RICKEN ACRES

RE: SUB 2003-45 -- Revised One-Step Final Plat of Ricken Acres Addition

**STAFF REPORT
(Revised One-Step Final Plat)**

CASE NUMBER: SUB 2003-45 -- RICKEN ACRES ADDITION

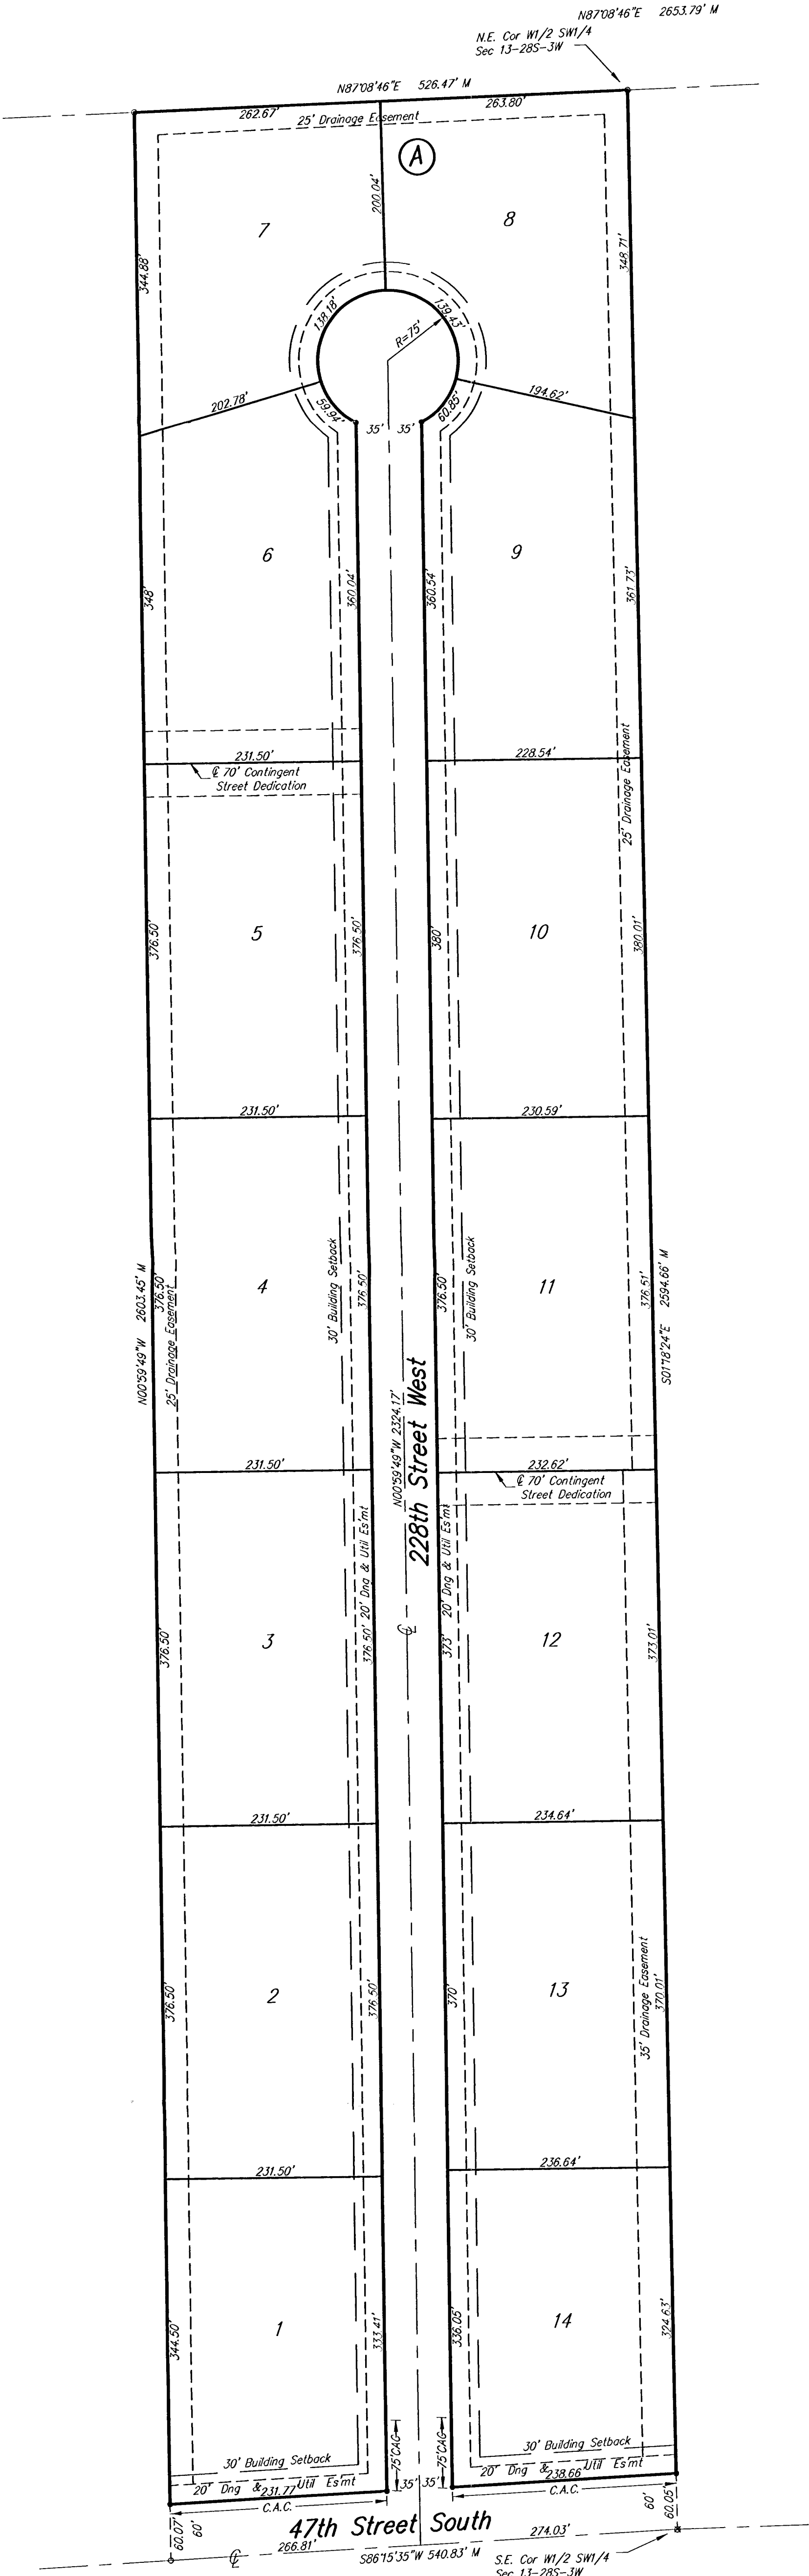
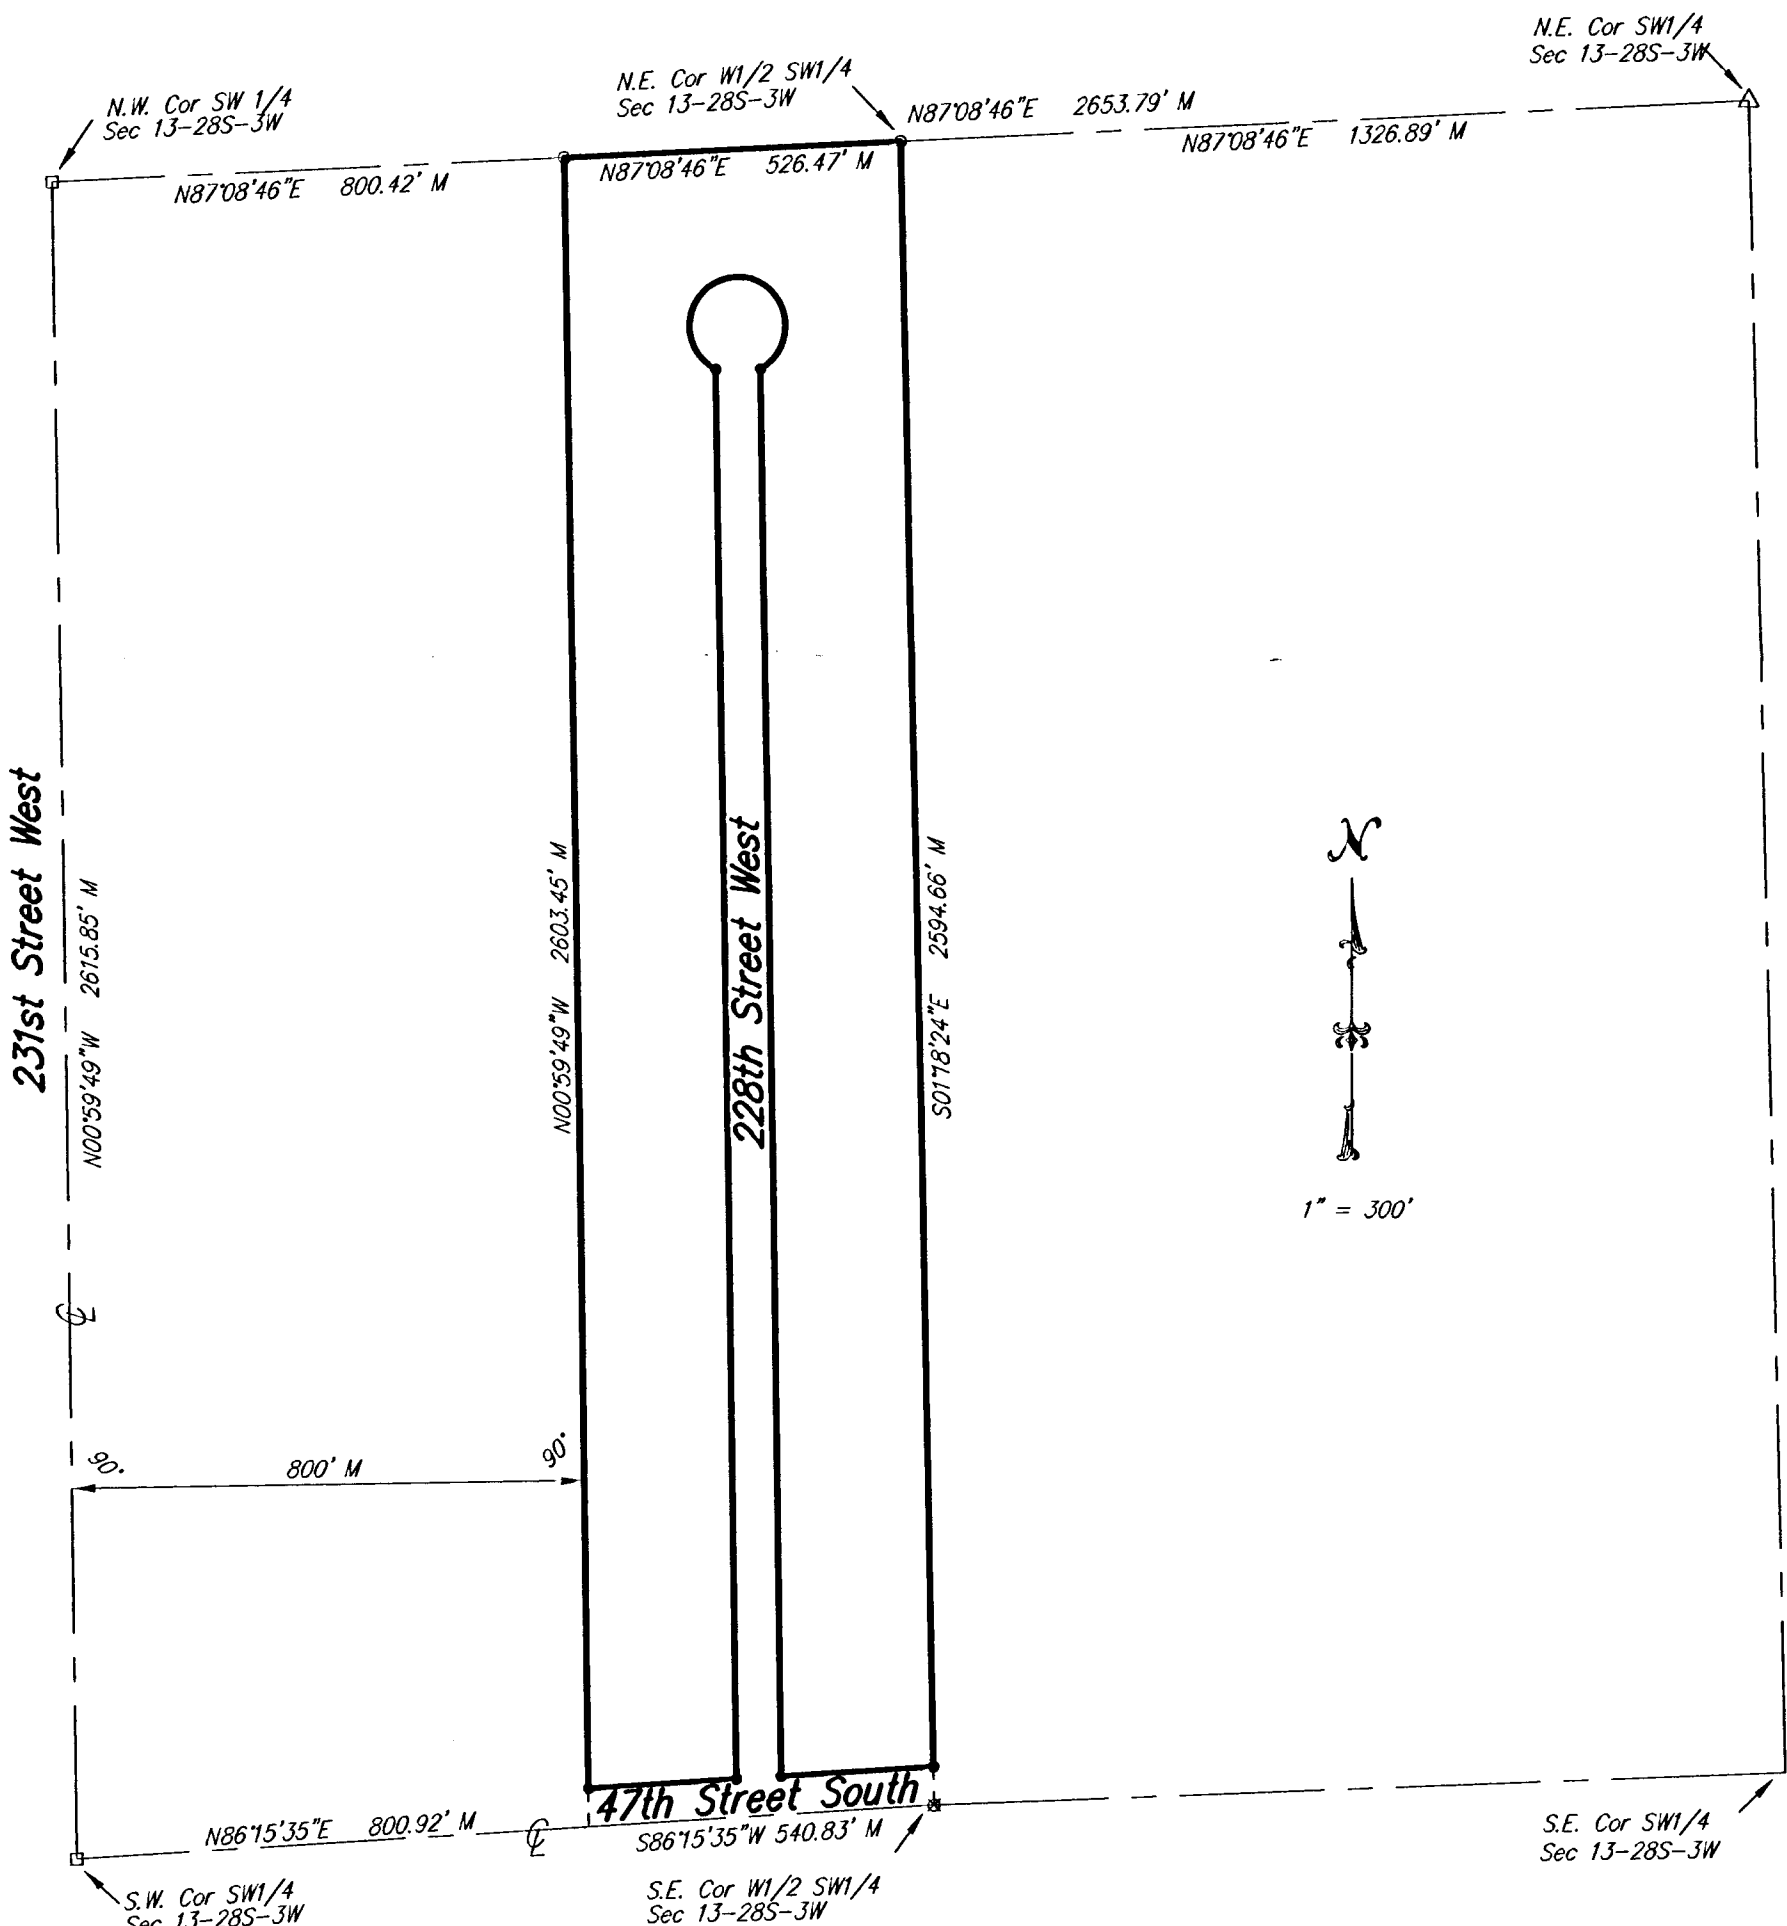
- E. **County Engineering** needs to comment on the status of the applicant's drainage plan. **A drainage plan is needed that addresses terraces and offsite drainage coming into plat from the east.**

- F. The applicant shall guarantee the installation of the proposed street to the 36-ft rock suburban street standard.
- G. Lots 1, 7, 8 and 14 contain less than the required 2-acre minimum lot size. A zoning adjustment will need to be approved for these lots. This adjustment should be submitted after the MAPC approval.

- I. The Applicant has provided a 70-ft contingent dedication of street right-of-way extending to the east line and west line of the plat in order to provide potential street connections to adjoining properties. MAPD recommends that the contingent street dedication to the west is relocated to the north between Lots 5 and 6.

- J. The MAPC signature block needs to reference "John L. Schlegel, Secretary".
- K. The County Fire Department/GIS needs to comment on the plat's street names. The street name shall be revised to "228th St W.

- E. **County Engineering** needs to comment on the status of the applicant's drainage plan. **A drainage plan is needed that addresses terraces and offsite drainage coming into plat from the east.**

- F. The applicant shall guarantee the installation of the proposed street to the 36-ft rock suburban street standard.
- G. Lots 1, 7, 8 and 14 contain less than the required 2-acre minimum lot size. A zoning adjustment will need to be approved for these lots. This adjustment should be submitted after the MAPC approval.

- I. **County Fire Department** needs to comment on the street length of 227th St. West Circle (2,300 feet) Rural cul-de-sacs over 1,200 feet in length must provide a stub street connection or contingent street dedication providing future access to adjoining tracts. The Applicant has provided a 70-ft contingent dedication of street right-of-way extending to the east line of the plat in order to provide potential street connection to adjoining properties. **MAPD recommends that the contingent street dedication to the west is relocated to the north between Lots 5 and 6.**

- J. The MAPC signature block needs to reference "John L. Schlegel, Secretary".
- K. The **County Fire Department/GIS** needs to comment on the plat's street names. **The street name shall be revised to "228th St W.**
